NOTICE OF PROPOSED CHANGE IN PROPERTY

Petition: X998

**REQUEST BERM USE
 (For Parking Only)
 INTO CANYON AVE
 AT 18401 WARREN AVE.**

CITY OF DETROIT CITY ENGINEERING DIVISION SURVEY BUREAU	
JOB NO.	01-01
DRWG. NO.	X 998

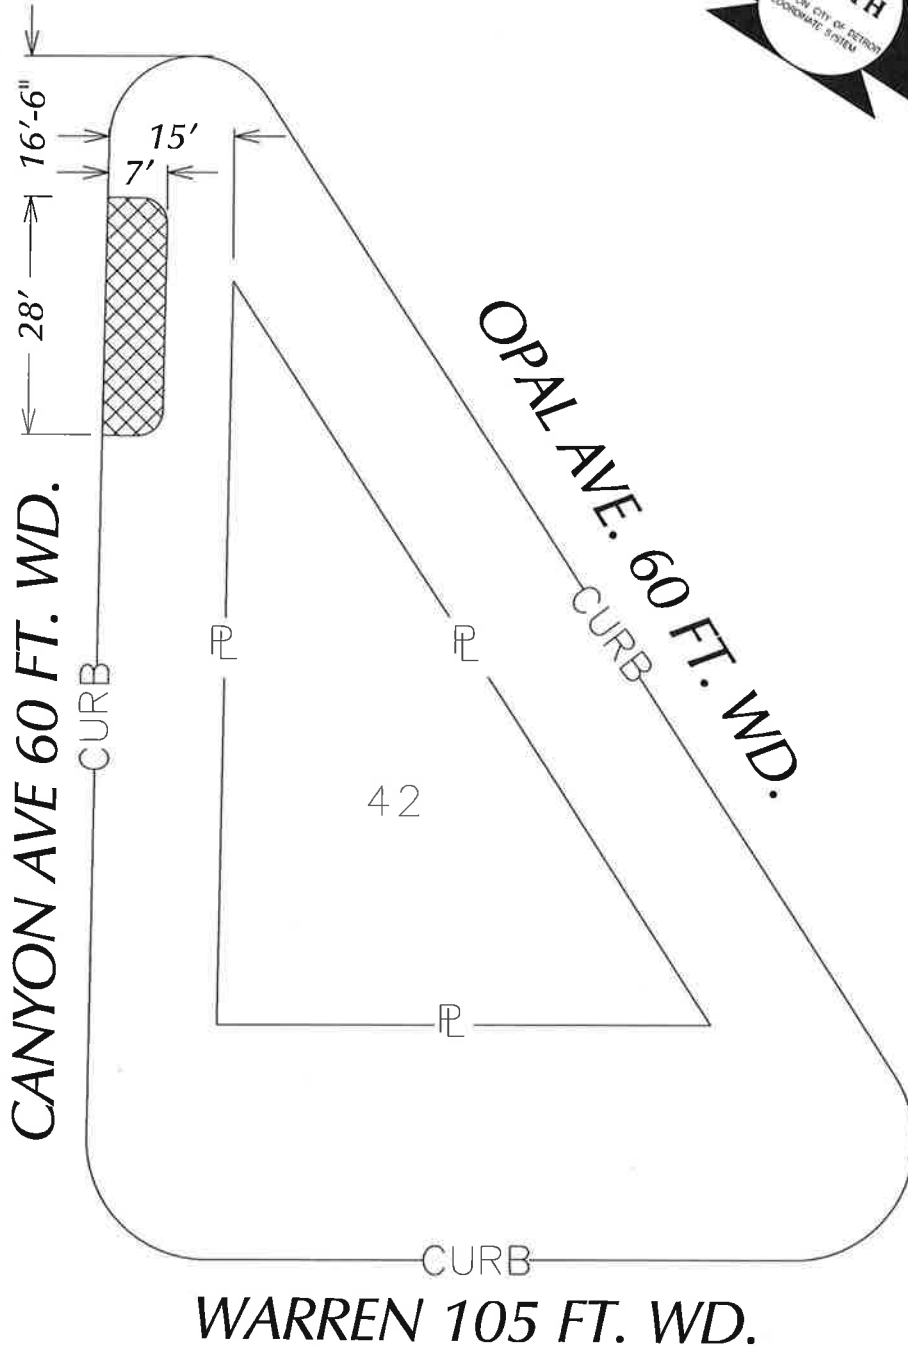
- Involved; objection to the property change.
Ample on-street parking exists on Canyon, Opal and E. Warren. Area requested for the parallel parking space is deficient per Zoning Ordinance standards.
